Access Compliance Report

Public Rights-of-Way

Intersection ID: 10011243	Main Street: E_21ST_ST	Cross Street: N/A	Location: W
ADA ID: 557F750A0F86	Ramp Type: Para	Initial Pass/Fail: Pass	Overall Compliance: No
		Severity Score: 0

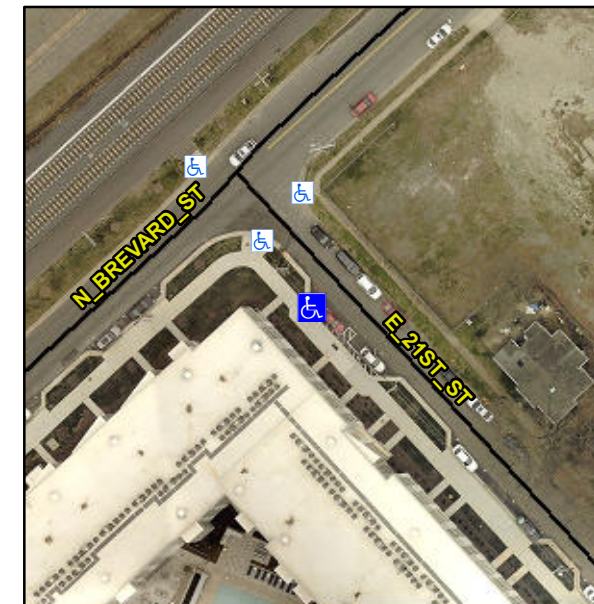
Possible Solutions:

Remove & Replace Landing.

ACCESS AISLE RAMP

R304.2.2-Perp, R304.3.2-Para
